REVISED RESPONSE TO REQUEST FOR ADDITIONAL INFORMATION

APR1400 Design Certification

Docket No. 52-046

RAI No.: 50-7911
SRP Section: 07.02 – Reactor Trip System
Application Section: 07.02
Date of RAI Issue: 06/23/2015

Figure 7.2-28 Functional Logic Diagram for Reactor Trip Signal Generation

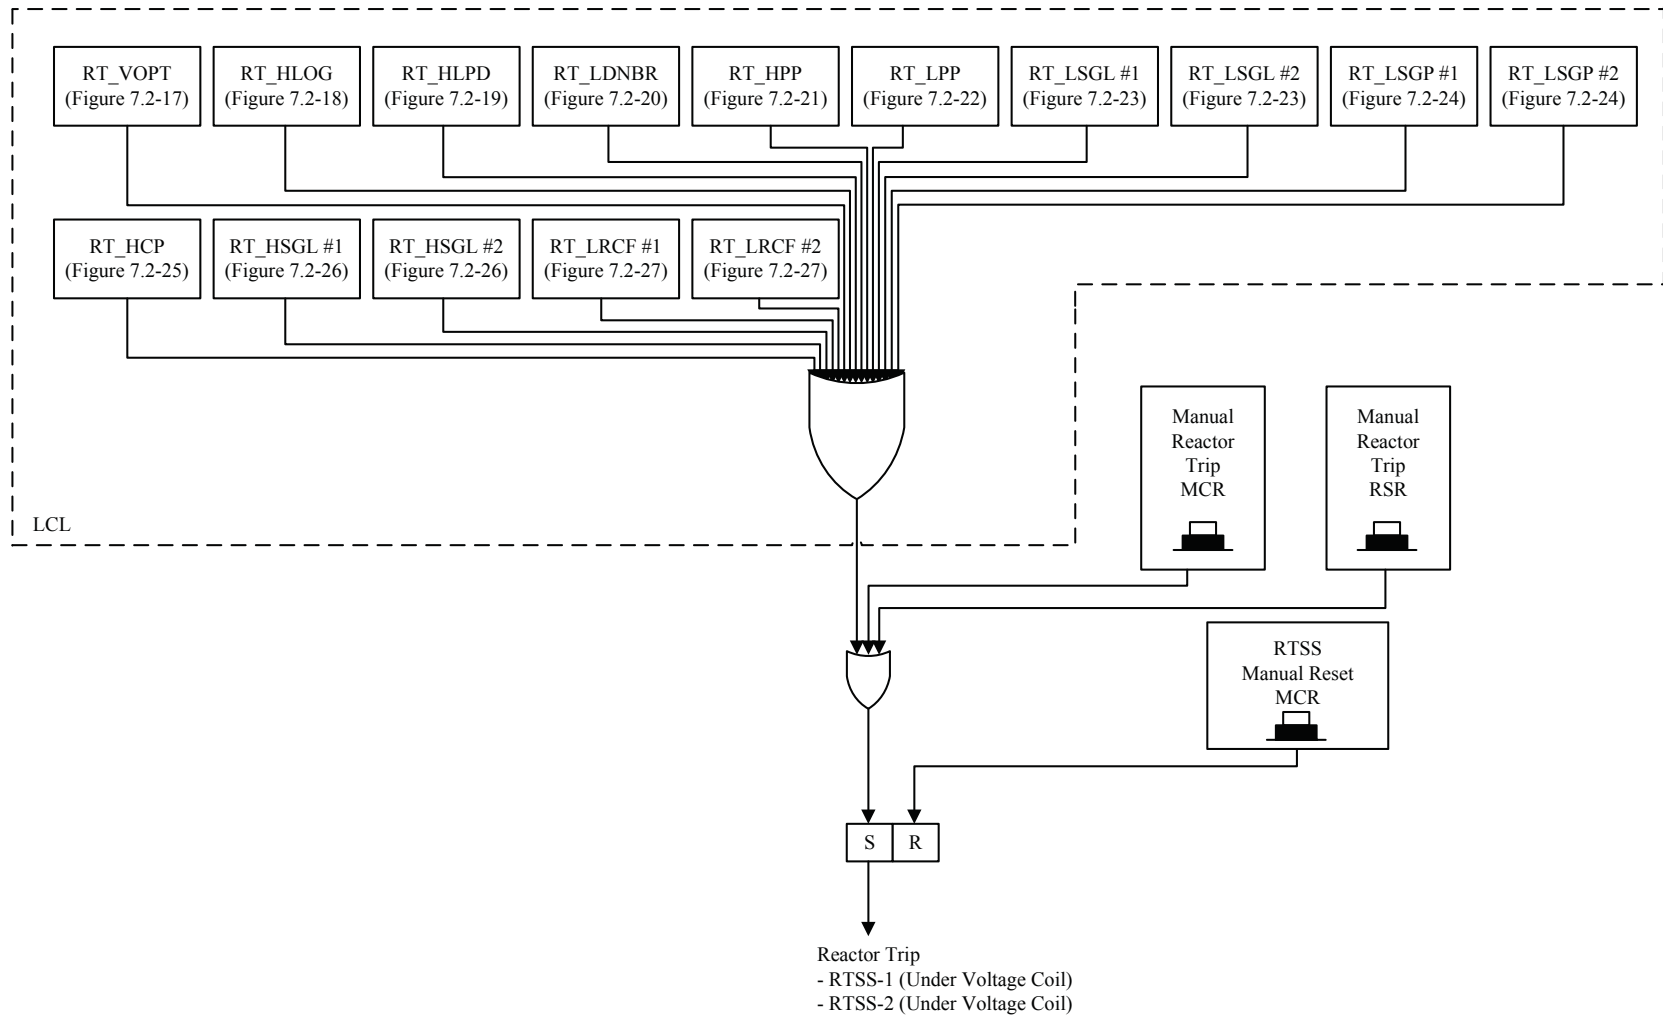
where the figures display only one division/channel (i.e., FSAR, Tier 2, Figure 7.2-10, “PPS Channel A Trip Path Diagram”) and where the schematics or diagrams of the figure display differences between the divisions/channels (i.e., FSAR, Tier 2, Figure 7.2-32, “Functional Logic Diagram for CWP”), insert a caption on the figures explaining whether the schematic or diagram shown is identical for all divisions/channels or insert a caption that describes what the differences are between the divisions/channels.

The description of identification is inserted into Figure 7.2-28 of DCD Tier 2 as shown in the attached mark-up for the case where some portion of the diagram shown in the figure is specific to certain channels or divisions. In this case, the manual reactor trip in RSR is applicable only for PPS divisions A and B. The remaining portion of the diagram in this figure is identical for all PPS divisions.

Note:

The manual reactor trip switches in the RSR are provided only for divisions A and B.
